CBD East Alignment and Station Refinement Technical Memorandum

Project: GPC6, C-2012668-02, Task Order #39 Dallas CBD Second Light Rail Alignment (D2 Subway)

Subject: CBD East Alignment Refinement Technical Memorandum

FIGURE 2. LPA CBD East Alignment Area (June 2017)

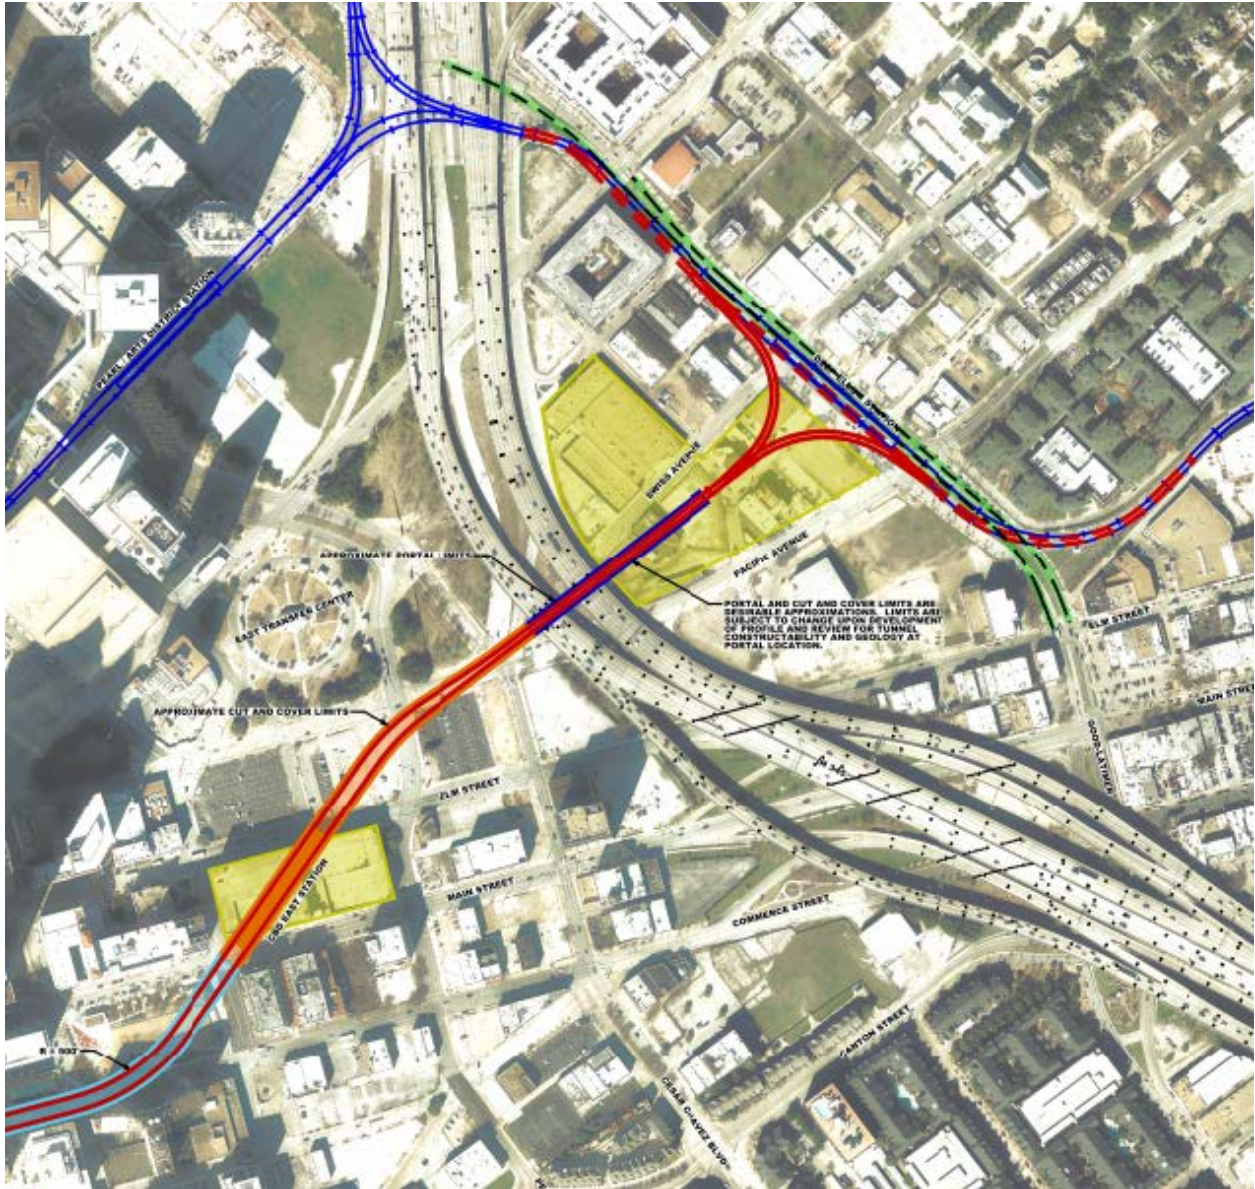
Figure 2 is an enlarged view of CBD East portion of the 2017 LPA alignment, showing the tunnel portion under Main Street Garden (blue shading) and cut-and-cover and mined construction (orange shading) near and under two adjoining Elm Street parking garages. The CBD East station platform would be directly under the western garage and partially under the eastern one, presenting challenges related to construction.

In addition, there would be potential for minor cut-and-cover construction impacts to the southern boundary of future Carpenter Park improvements. This section of the alignment would pass through surface parking lots and would not impact any existing structures except for the parking garages.

1. Temporary underpinning and building foundation load transfer to station’s final lining. This approach is not recommended due to the extensive underpinning that will be required and the magnitude of the loads that will need to be supported by the station’s final lining.

2. Permanent underpinning of existing foundations outside the station limits. This requires the use of a permanent framing system and foundations outside the station's limits. This approach is also not recommended since it is considered not practical and of high risk to the existing parking structure.

3. Revising the vertical alignment and relocation of the station. Lowering the vertical alignment and relocating the station in the southwest direction will result in avoiding the underpinning of the existing garage structure and permit the excavation of the station with competent rock cover. Shifting the station and lowering the vertical profile avoids interference with the heavily loaded foundation piers above the station, where the rock cover is less; however, the foundations piers would now be situated above the running tunnel and their impact on the running tunnel will need to be also evaluated. However, shifting the station to the east locates it too close to Commerce Station, and would not be feasible given the alignment curve under Main Street Garden park.

For both underpinning alternatives, in addition to the large number of columns and magnitude of loads that will need to be supported, at least 20 columns would be impacted and could create damages to the existing structure due to extensive structural reframing, jacking and load transfer operations. There would also be time restrictions and parking garage closures to perform the work.

- The tunnel under Main Street Garden Park would require a subsurface easement creating potential 4(f) de minimis impact. No direct impacts would be expected.
- The tunnel and subway station under Elm Street Parking Garage presents challenges and the parking garage would require foundation underpinning. Construction activities under the parking garages may require closure of the garages for an extended period, pending further analysis.

Park representatives also voiced concern with the potential for tunnel-to-surface transition impacts along the southern edge of future Carpenter Park. Park construction will begin soon and there would be a need for a subsurface easement with potential 4(f) de minimis impact.

Figure 4. Current D2 Subway Alignment in CBD East Area

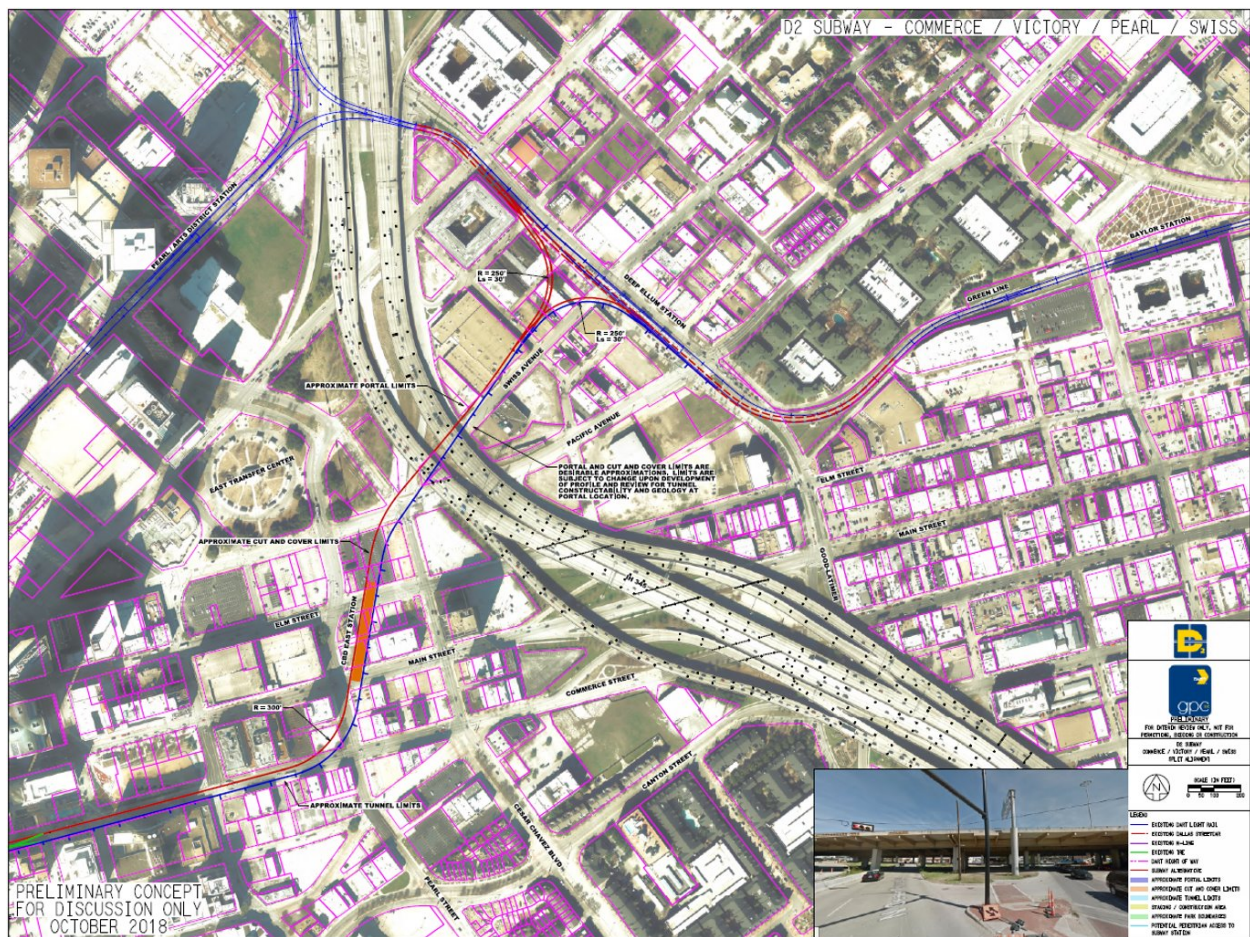
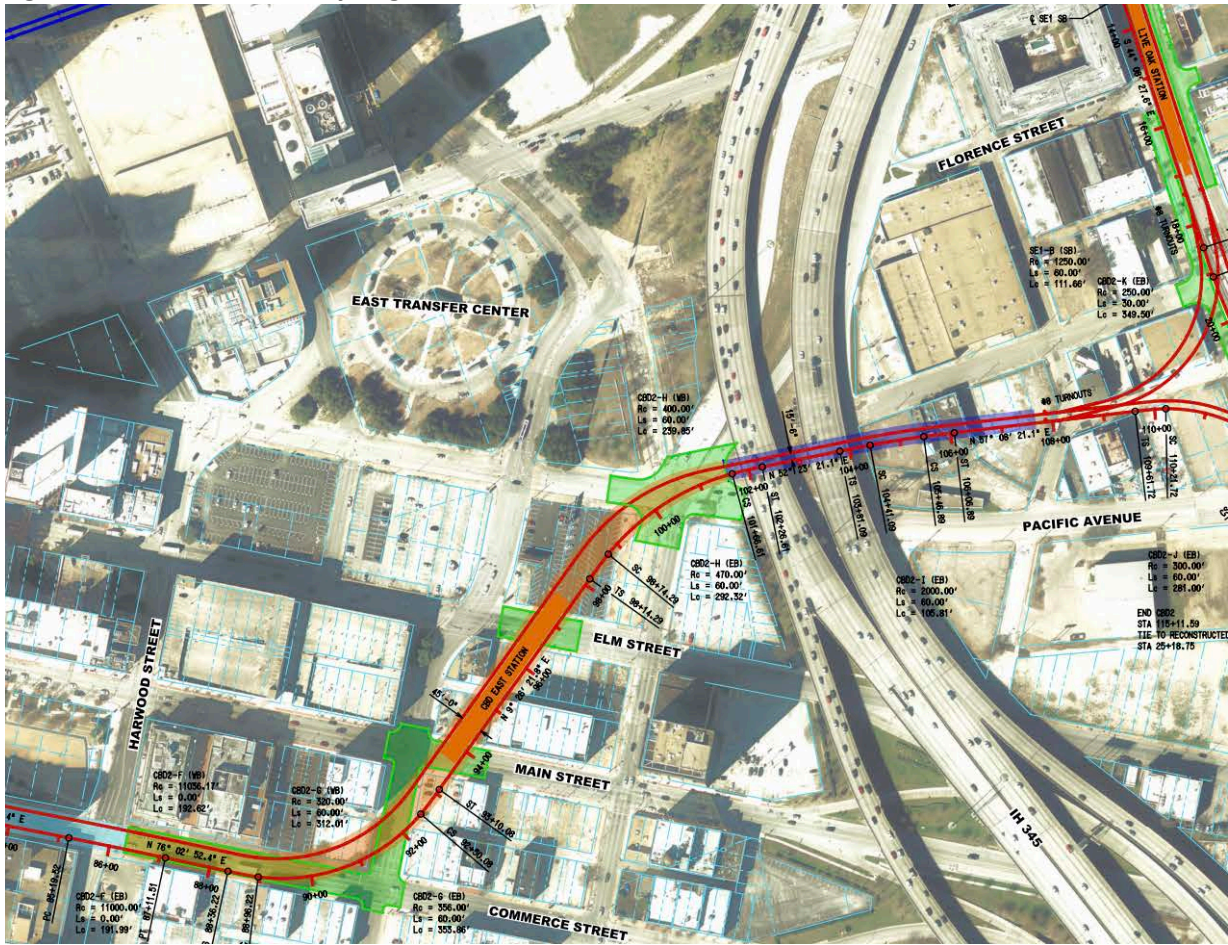
In response to comments from CBD East stakeholders, as well as due to engineering concerns with underpinning the garages and potential park impacts, a CBD East alignment refinement was developed. The refinement was developed with a focus of avoiding any potential impact to both the Elm Street garages, existing Main Street Garden Park and future Carpenter Park. This alignment would begin to curve north at Pearl Street instead of Harwood. Figure 3 depicts the CBD East alignment refinement concept presented in October 2018. Figure 4 illustrates the latest CBD East alignment which was adjusted to allow for a station at Live Oak and to accommodate operational needs between the two junctions.

Note: Above graphic was subsequently changed to include south of Swiss connection with Live Oak Station.

- Avoids any potential impact to Main Street Garden park.
- Realignment of tunnel and relocation of subway station location avoids any impact to the Elm Street parking garages.

- Cut and cover portion of alignment avoids any potential physical impacts to the planned Carpenter Park improvements.
- Avoids any impact to the large surface parking lots along Main Street immediately to the north of the Elm Street Parking Garages, which have potential development opportunity. However, the refined alignment would impact smaller surface parking lots between Pacific Avenue and Commerce Street. The alignment would still allow for air rights development.

- Acquisition of at least two small buildings at 2107/2109 Main Street (printing business) and 2204 Elm Street (small nightclub) would be required, including relocation of businesses. These structures were surveyed as part of the historic resource documentation.

- Impacts to 2121 Main Street, which was the original Central Fire Station, are not anticipated. This structure is also not eligible for the NRHP.
- The relocated CBD East Station has similar transfer distance to DART East Transfer Center as the original LPA Alignment.
- Location of the CBD East Station would improve accessibility to Deep Ellum, Farmers Market and the redeveloping East Quarter area.
- The refined alignment introduces tight radii and minimum tangents at ends of the platform; however, speeds will be slower coming in and out of the station.
- The cost of the refined alignment would likely be slightly lower given the avoidance of significant engineering requirements or potential acquisition or closure of the Elm Street garages.
